SUNDRY NOTICES AND REPORTS ON WELLS

2. NAME OF OPERATOR
Supron Energy Corporation

8. FARM OR LEASE NAME
Zachry

9. WELL NO.
16-E

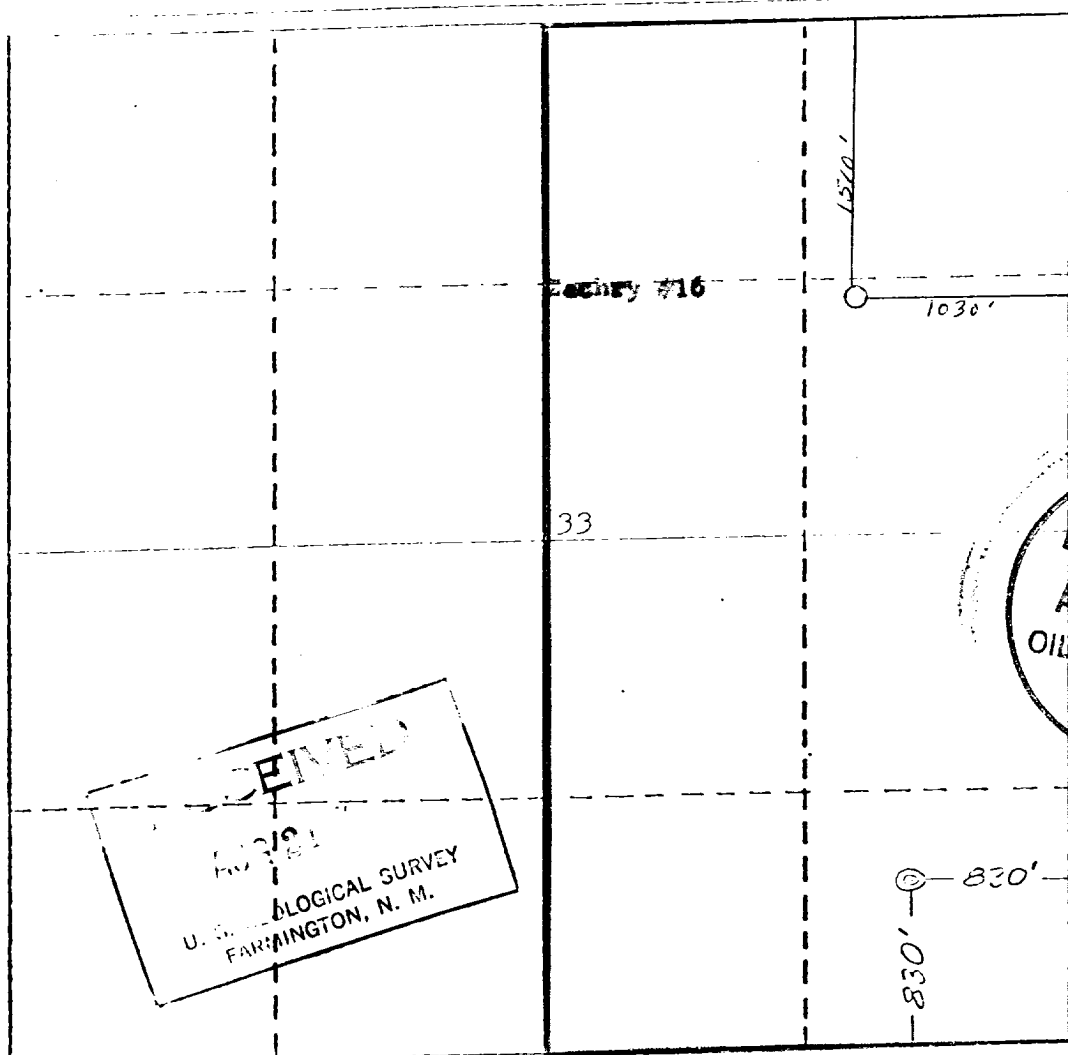
Change ground level elevation from 5737 ft. to 5781 ft.
